Section <b>09</b>	Applicable Model/s <b>1999 Miata</b>	Subject <b>SOFT TOP COVER COMES OFF OR BREAKS</b>	Bulletin No. <b>007/99R</b>
			Issued <b>05/21/99</b>
			Revised <b>06/04/99</b>

### BULLETIN REVISION NOTE

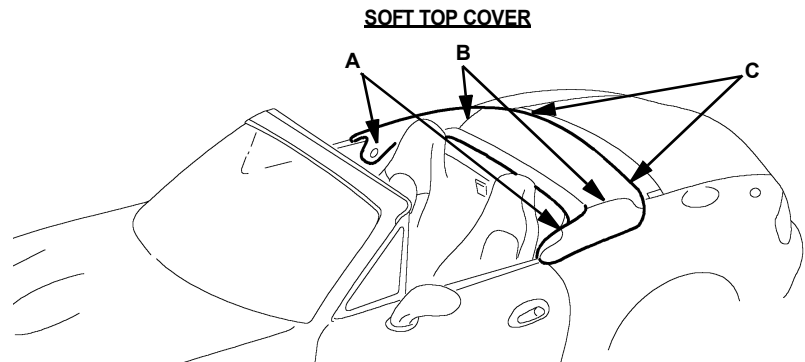
The soft top cover may exhibit the following conditions:

- A. Soft top may tear when trying to remove it due to fasteners connecting too tightly.
- B. Soft top cover cloth gradually comes apart at the seams due to wind pressure.
- C. Soft top cover fastener(s) may fly off from wind pressure while driving.

A modified part is available which has been reinforced, stitched at the seams, and shorten for a tighter fit.

- Verify customer concern.
- Replace soft top cover with modified part.
- Verify repair.
